**Comparison of an Ultrasonic Phased Array Evaluation with Destructive Analysis of a Documented Leak Path in a Nozzle Removed from Service**

AD Cinson, SL Crawford, PJ MacFarlan, BD Hanson, and RA Mathews  
Pacific Northwest National Laboratory<sup>1</sup>, Richland, WA, USA

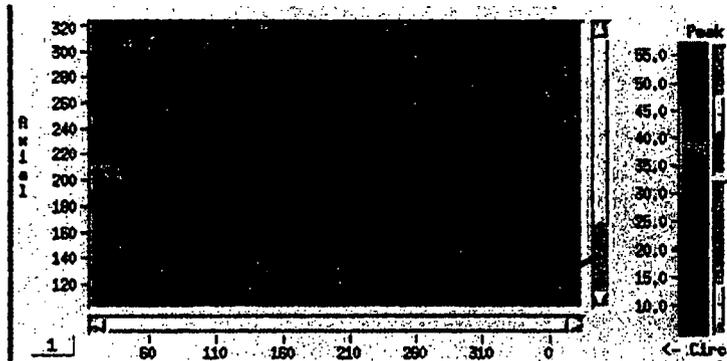
Comment [P0011]: Confirm you have permission to use this figure and make publically available.

Figure 8 – Replicated leak path on the left and piece 4 on the right with machining marks evident. The red line on the right represents 2.0 mm (0.80 in.) in length.

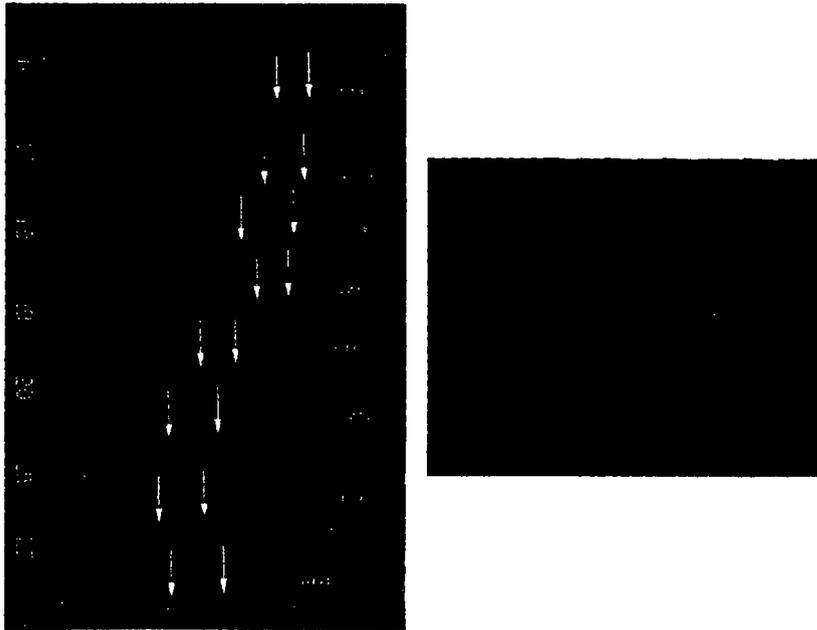
Comment: P-0251: Make it clear that this statement applies to the presence of visible machining marks, not the corroded area.
